CONSTRUCTION SUMMARY			
The Post - Silk Westerns Corporation			
PURCHASERS: Houman RAHBARITABAR and Behnaz DOLATYARI			TEL:
Unit 14, Level 7 (715-1)	Floor Plan A519

Suite 715, Unit 14, Level 7

A519

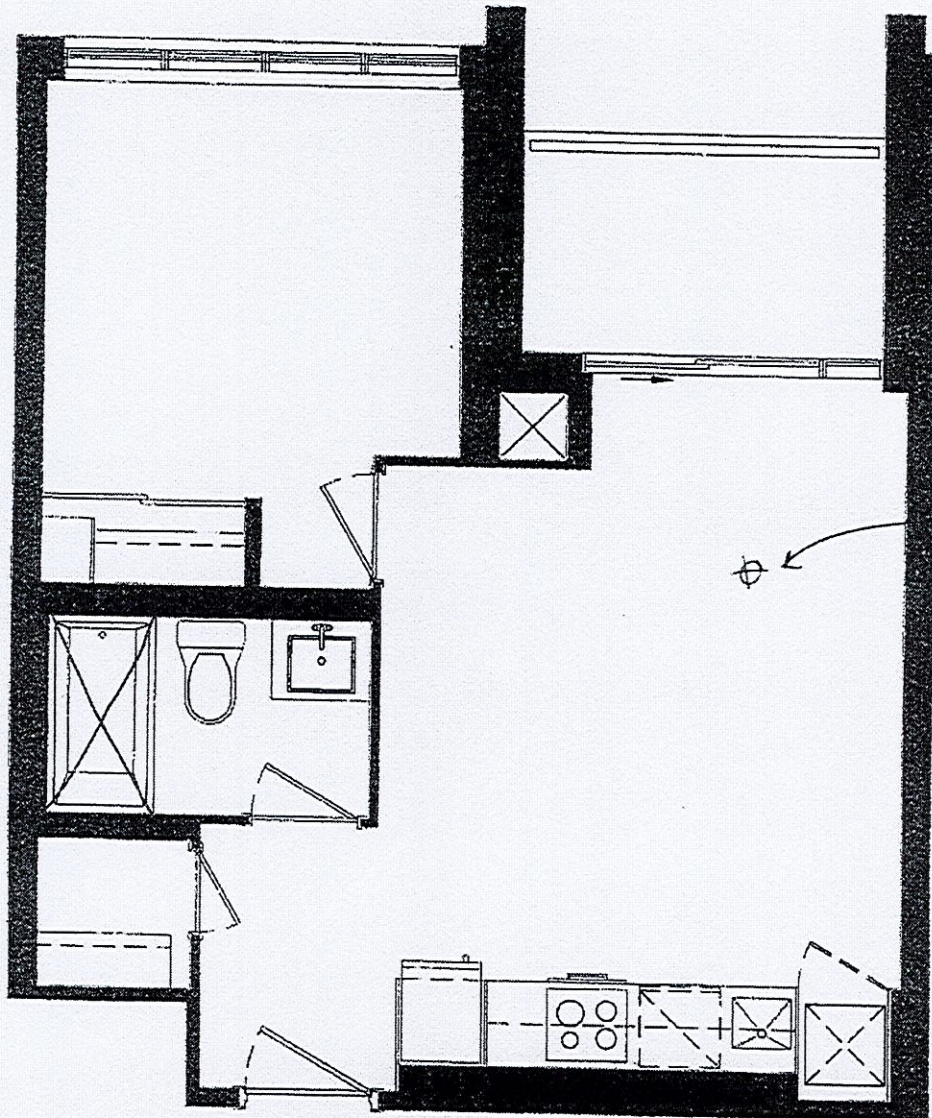
1 - ***INSERT*** - TUB TO SHOWER CONVERSION - INCLUDES CLEAR GLASS FRAMED SLIDING DOORS CHROME FINISH, PREFORMED SHOWER BASE AND SHOWER POT LIGHT - MAIN BATHROOM 04May23 Note: <u>FOR CONFIRMATION ONLY -- SHOWER BASE IS PREFORMED AS PER SCHEDULE D</u>	★ ★ ★
1 - ***DELETE*** - TUB TO SHOWER CONVERSION - INCLUDES CLEAR GLASS FRAMED SLIDING DOORS CHROME FINISH, MOSAIC SHOWER BASE 2X2 WHITE AND SHOWER POT LIGHT 04May23 Note: IN REFERENCE TO PE#28229	
1 - TUB TO SHOWER CONVERSION - INCLUDES CLEAR GLASS FRAMED SLIDING DOORS CHROME FINISH, MOSAIC SHOWER BASE 2X2 WHITE AND SHOWER POT LIGHT 14Feb23 Note: MAIN BATHROOM *updated

1 - LIGHT - ADD CEILING LIGHT COMPLETE WITH FIXTURE AND SWITCH 14Feb23 Note:	
---	--

Convert
Tub to Shower
